PROPOSED INDUSTRY BUILDING

LOT 16 EDISON CRESENT, YARRABILBA, QLD 4207

AMENDED IN RED

PLANS AND DOCUMENTS
referred to in the PDA
DEVELOPMENT APPROVAL

1 ROOF PLAN
1-03 1 : 100 @ A1

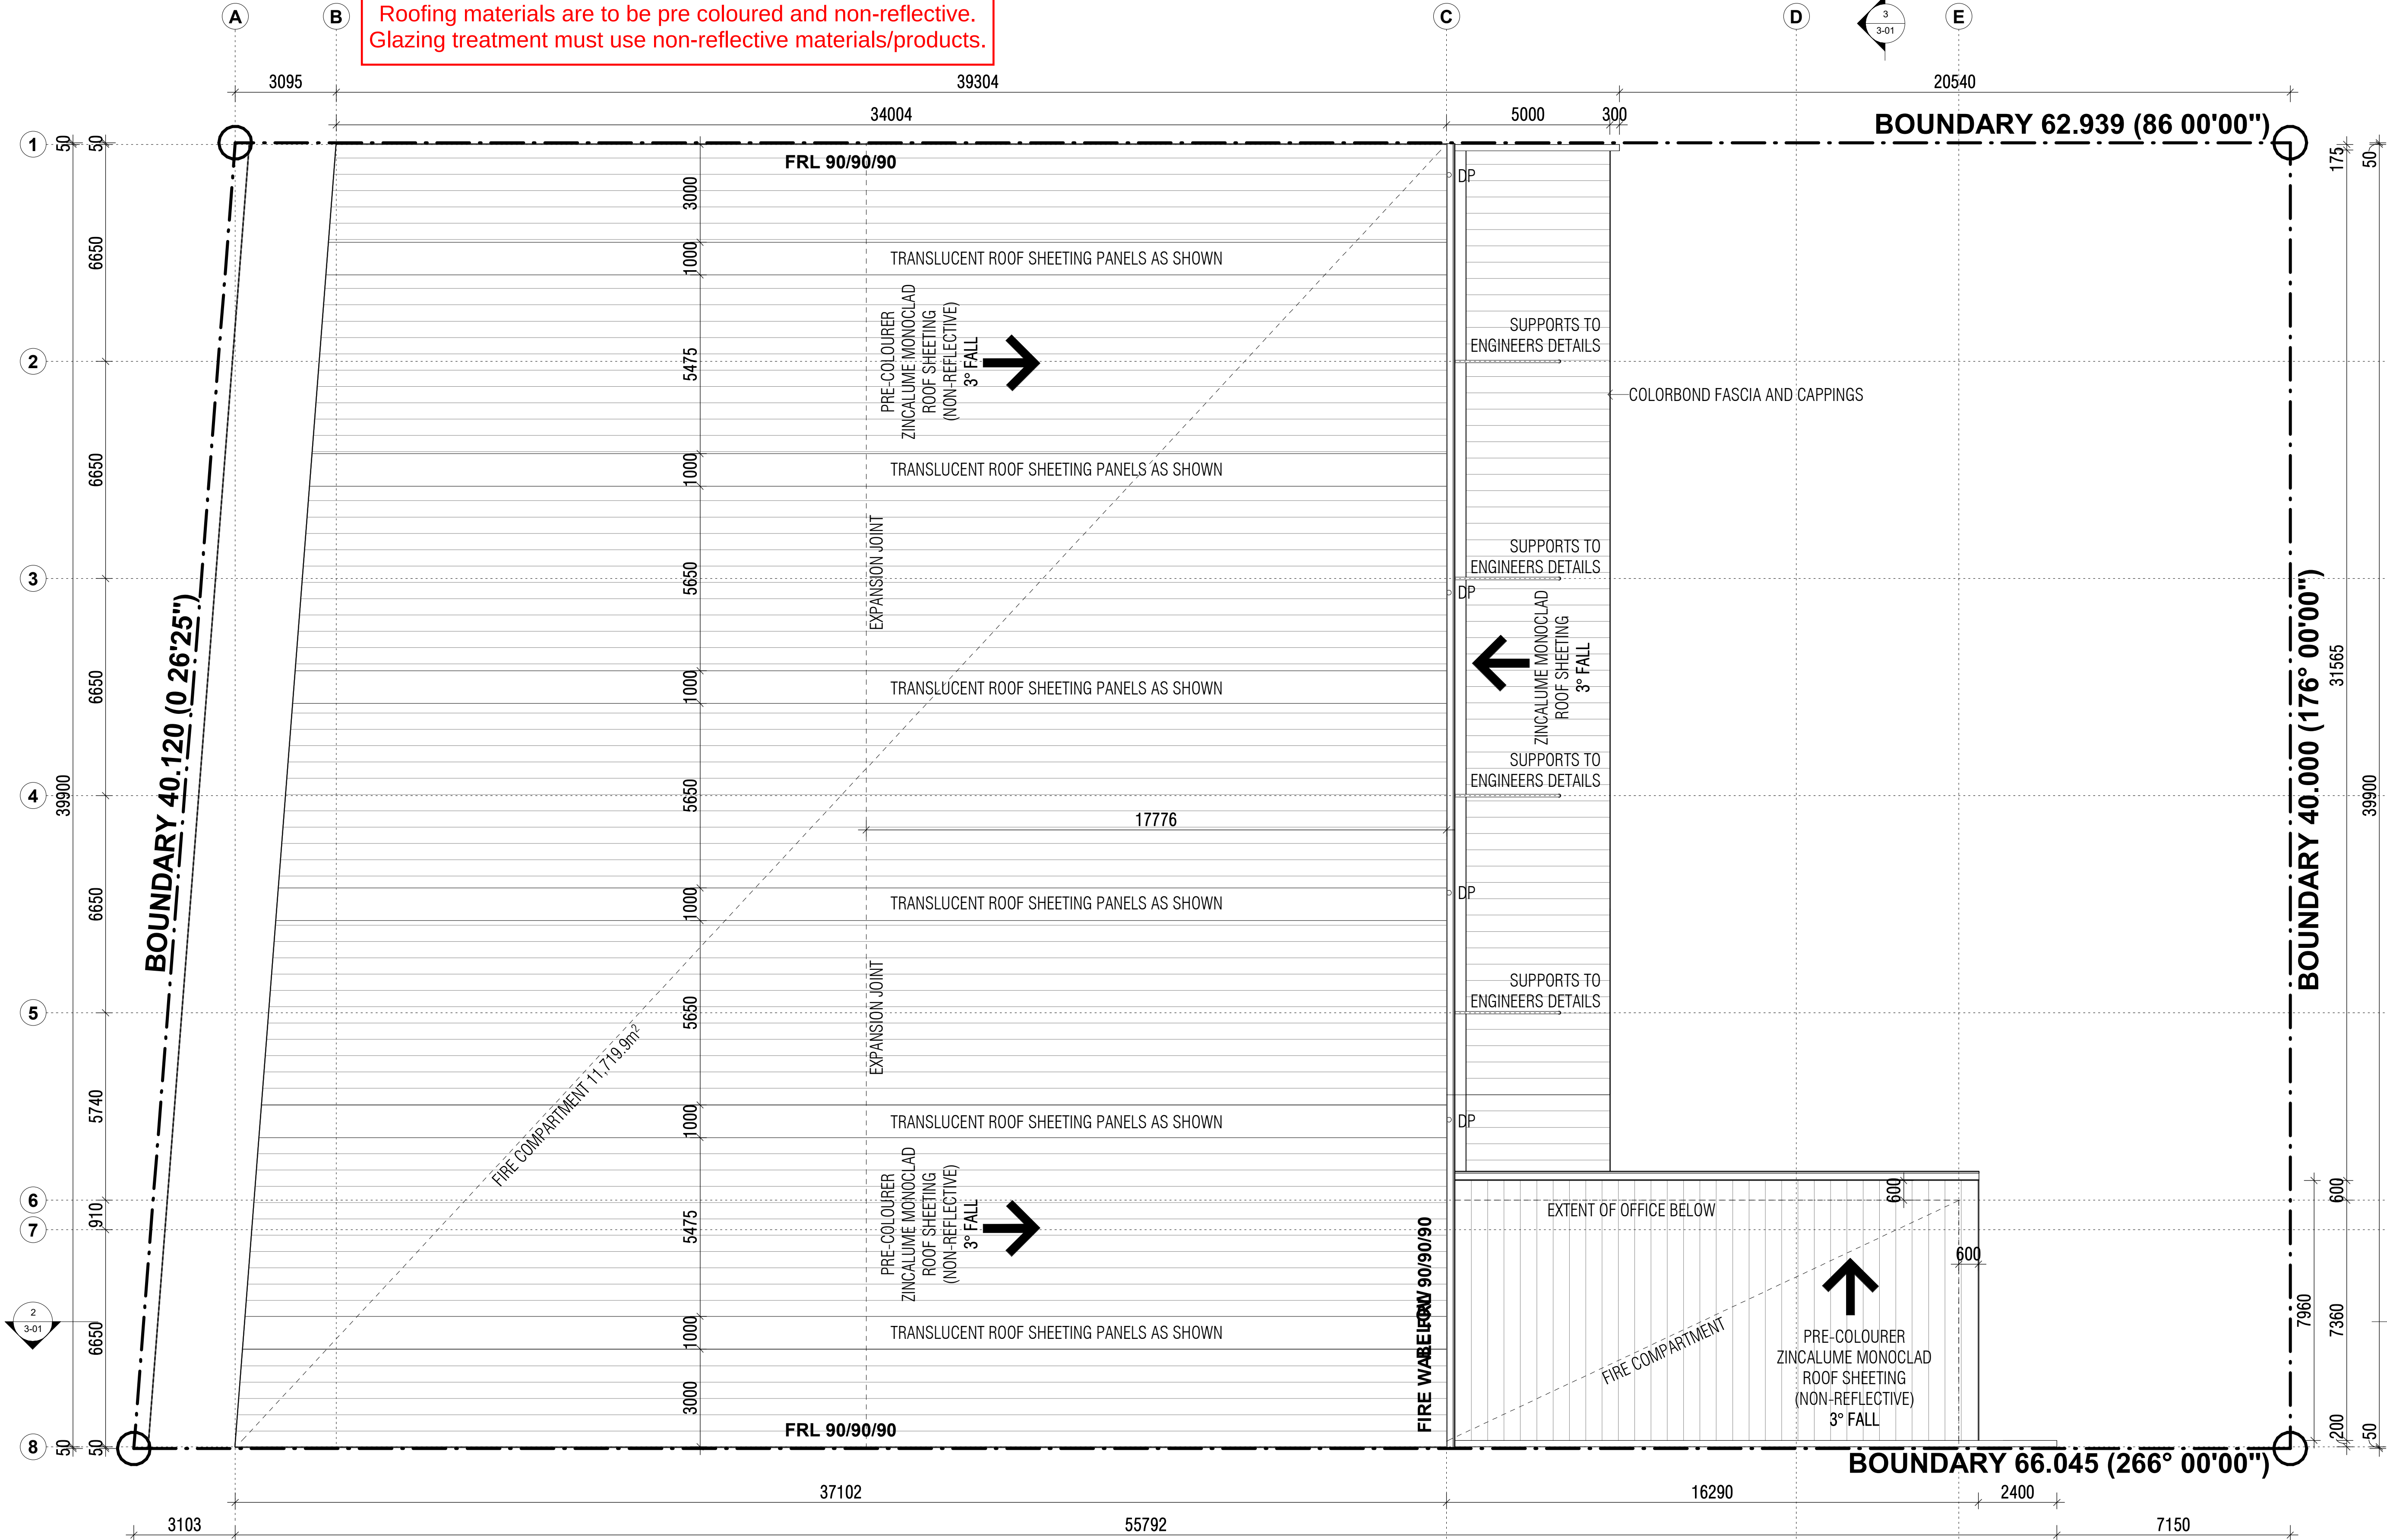
Roofing materials are to be pre coloured and non-reflective.
Glazing treatment must use non-reflective materials/products.

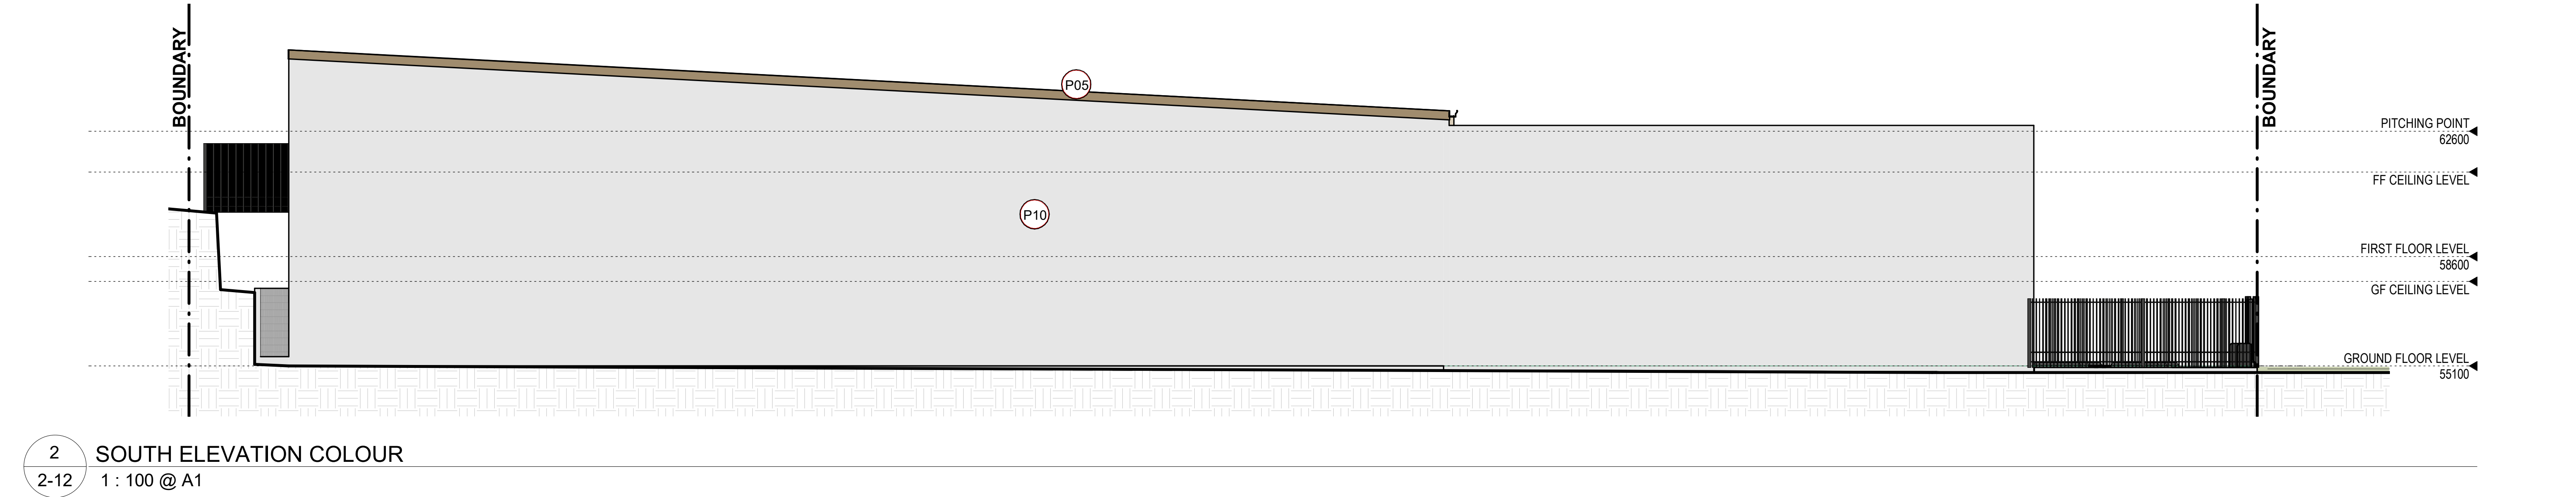
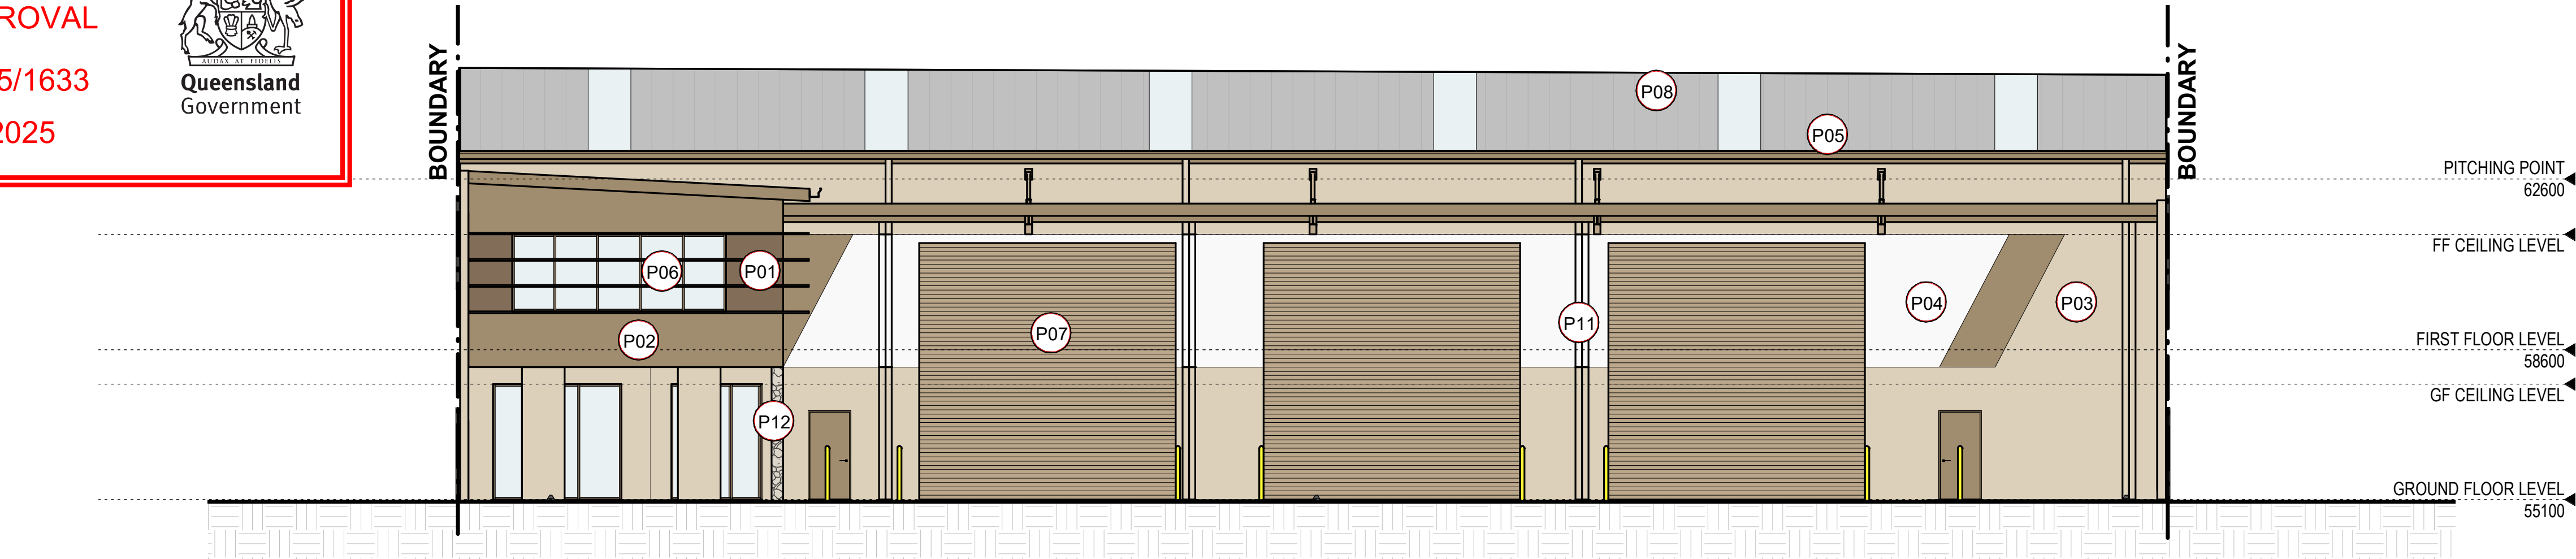
REF	COLOUR	ELE REF	DESCRIPTION	LOCATION
P05			POWDER COATED FINISH DULUX COLORBOND: DULUX: STONE CROP CODE: S14D7	GUTTERS, CAPPINGS, STRUCTURAL SUPPORTS
P06			GRD: TINTED GLASS FST: TINTED GLASS FRAME POWDERCOATED COLORBOND: JARRAH	ALL WINDOWS AND ENTRY DOOR
P07			POWDER COATED FINISH DULUX COLORBOND: DULUX: STONE CROP	ALL ROLLER DOORS
P08			ZINCALUME ROOF SHEETING PRE-COLOURED NON REFLECTIVE WITH TRANSPARENT INSERTS	ALL ROOFS

Roofing materials are to be pre coloured and non-reflective.
Glazing treatment must use non-reflective materials/products.
